ENGINEERING CHANGE NOTICE NO.

04765

DWG NO. 646.3300

DWG TITLE: UPPER CUTTER ASSY

SHEET 5 IS:

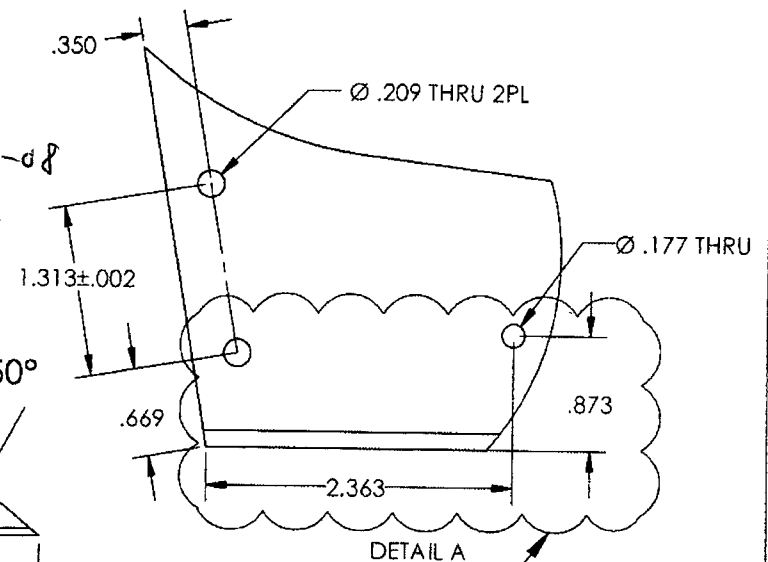
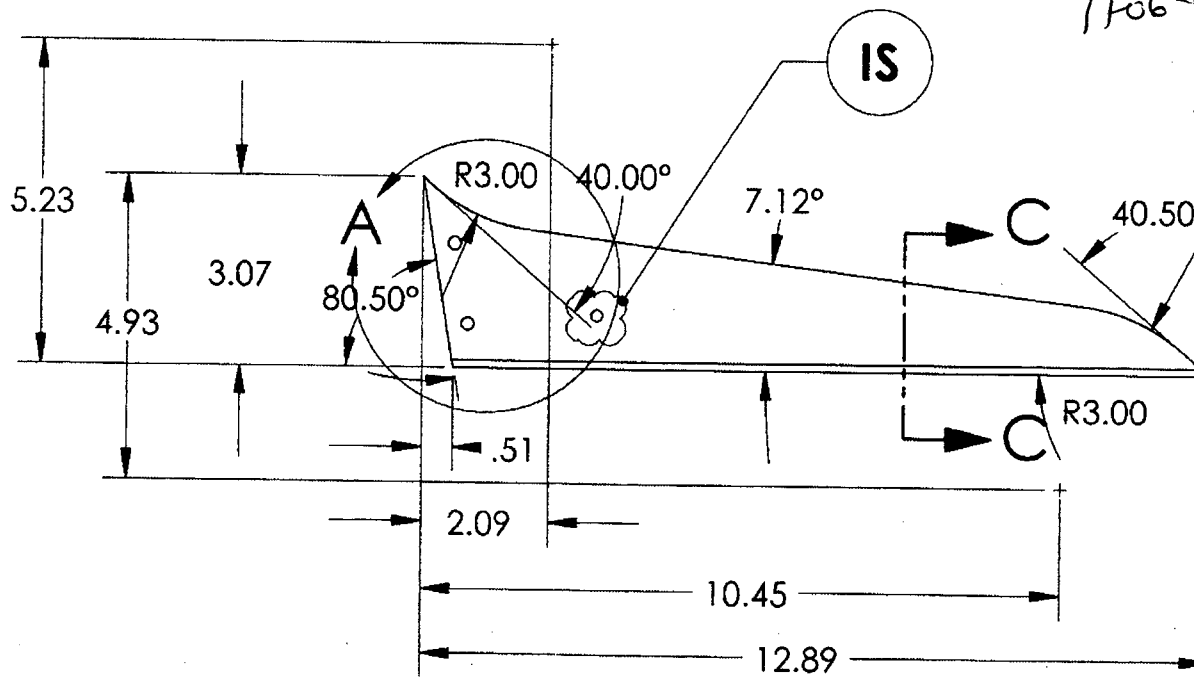
REASON: ADDED HOLE DIMENSION TO 646.3313.

SHEET 4, ZONE B8 IS:

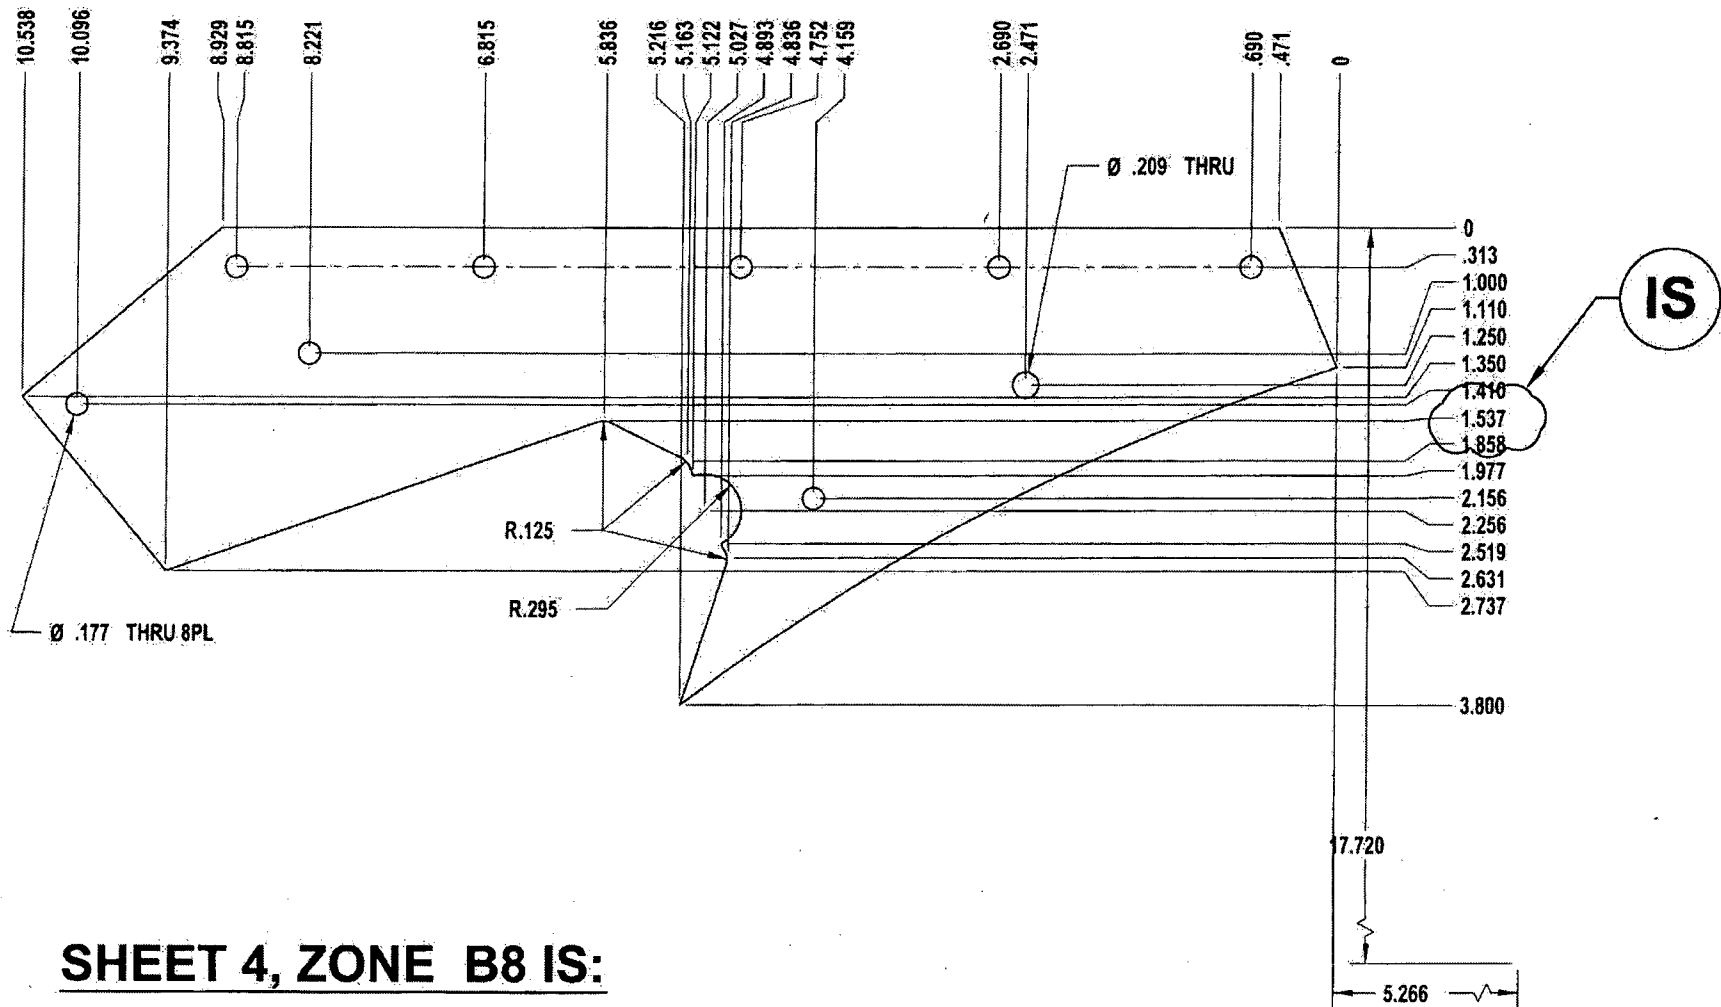
APICAL INDUSTRIES, INC.	ENGINEERING CHANGE NOTICE NO. 03724				SHEET 1 OF 1	
	DWG NO. 646.3300	REV: N/C	PREPARED BY: B. PETERS	DATE: 12/05/12	EFFECT ON DWG ☐ INC. ☒ UNINC.	
	DWG TITLE: UPPER CUTTER ASSY					
	APPROVED BY: ENGR <i>[Signature]</i>	MFG <i>[Signature]</i>	QC <i>[Signature]</i>	EFF: NEXT ORDER		
TRANSACTION CODES (TC): A-ADD C-CREATE R-REVISE D-DELETE	REASON: REVISED ORDINATE DIMENSION.				ECR: D-12-025

SHEET 1, VIEW 646.3301, IS:

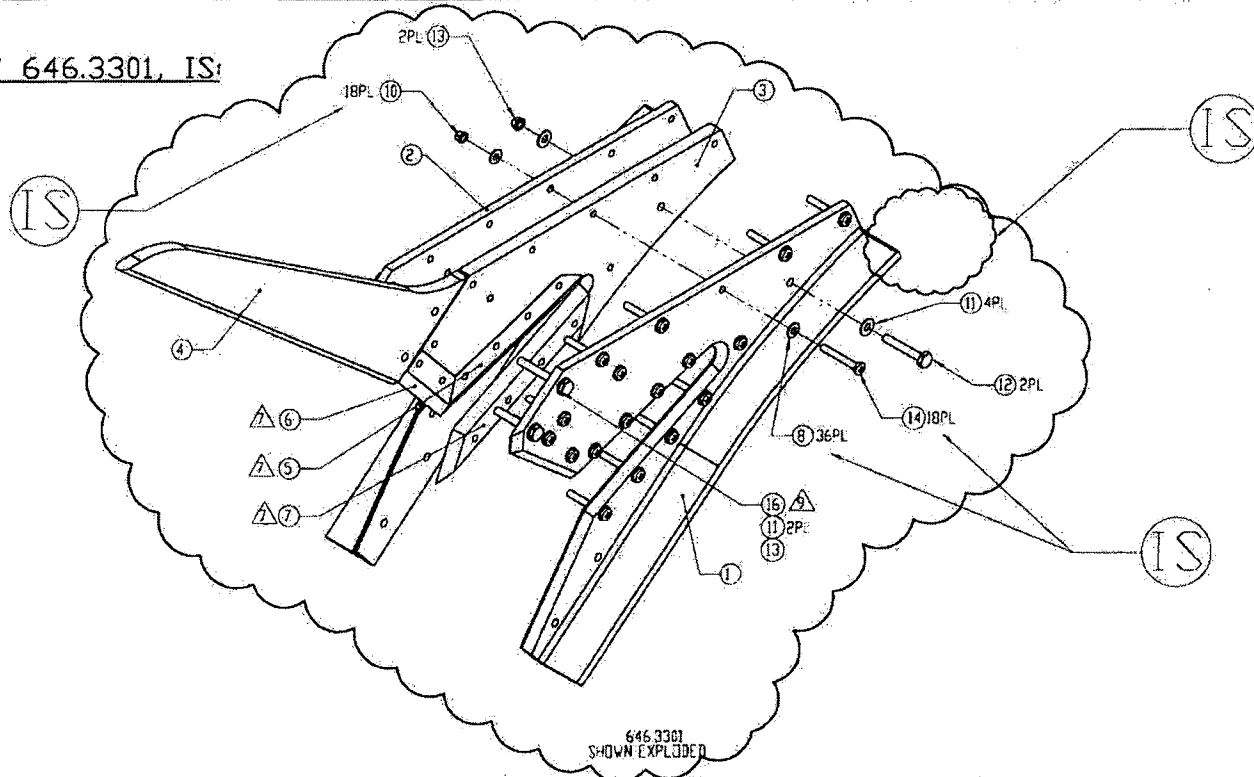
APICAL INDUSTRIES, INC.	ENGINEERING CHANGE NOTICE NO. 02196		SHEET 1 OF 2	
	DWG NO. 646.3300	REV: N/C	PREPARED BY S. HUFF	DATE: 01/05/09
	EFFECT ON DWG ☐ INC. ☒ UNINC.			
DWG TITLE: UPPER CUTTER ASSY				
APPROVED BY: ENGR <i>[Signature]</i>	MFG <i>[Signature]</i>	QC <i>[Signature]</i>	EFF: NEXT ORDER	
REASON: REMOVED RIVETS IN FAVOR OF ADDITIONAL SCREWS				
TRANSACTION CODES (TC): A-ADD C-CREATE R-REVISE D-DELETE

14	R	601.2765	18	SCREW	MS27039-0819
10	R	601.1541	18	LOCKNUT	MS21042L08
9	D	601.2766	3	RIVET	MS20470AD5-18
8	R	601.2764	36	WASHER	NAS1149FN832P
			3301		
F/N	TC	PART NUMBER	QTY	DESCRIPTION	MATERIAL/SPECIFICATION
DOCUMENTS EFFECTED:					CHANGE CATEGORY
☐ MDL ☒ INSTALL INSTRU ☒ ICA ☐ FMS ☒ BOM					☐ MAJOR ☒ MINOR
DER REVIEW REQUIRED					☐ YES ☒ NO
